Re: FCC ID PU5MS2133
Applicant: Wistron Corporation
Correspondence Reference Number: 25598
731 Confirmation Number: EA859241

Here are the responses to the questions set by Diane Poole from the FCC.

Question 9.

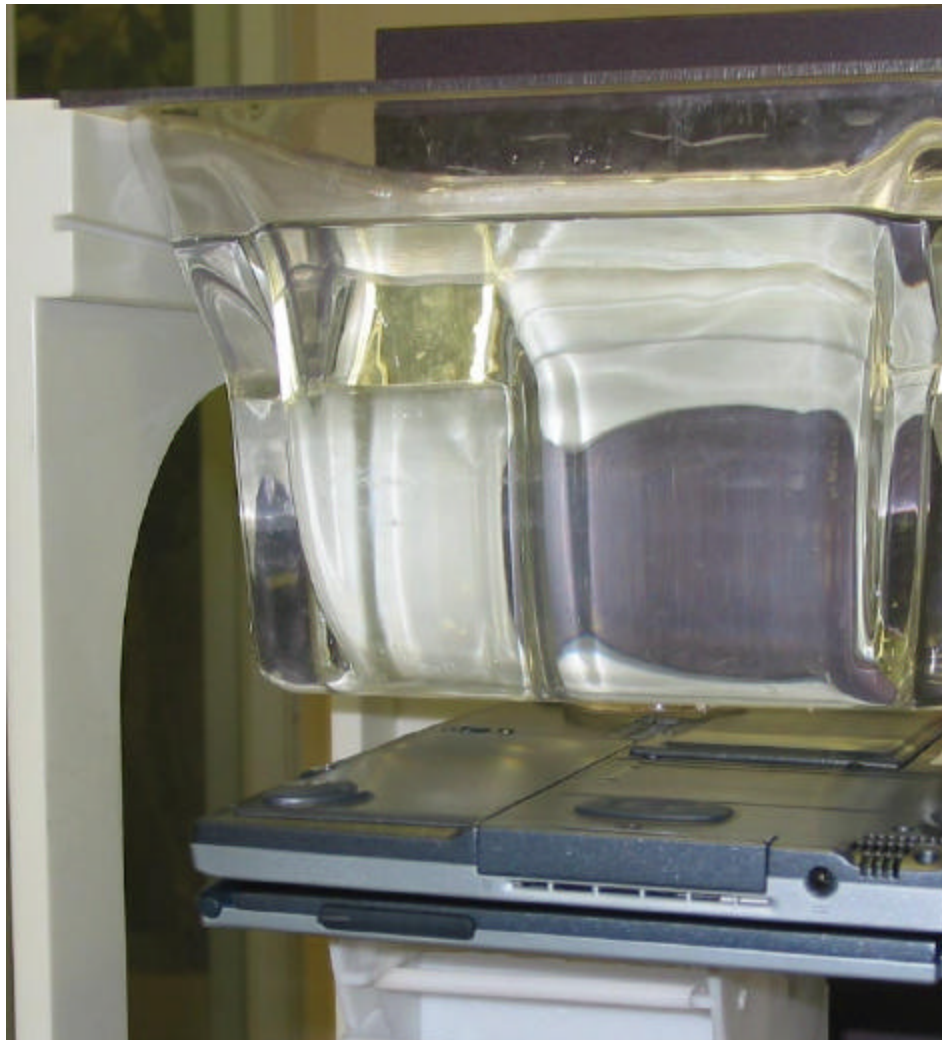
Photograph for keyboard down tablet mode.

The image for keyboard down while in tablet mode is presented on the next page. It should be noted that the keyboard down mode, is similar to that which is presented while the unit operates with the LCD closed.
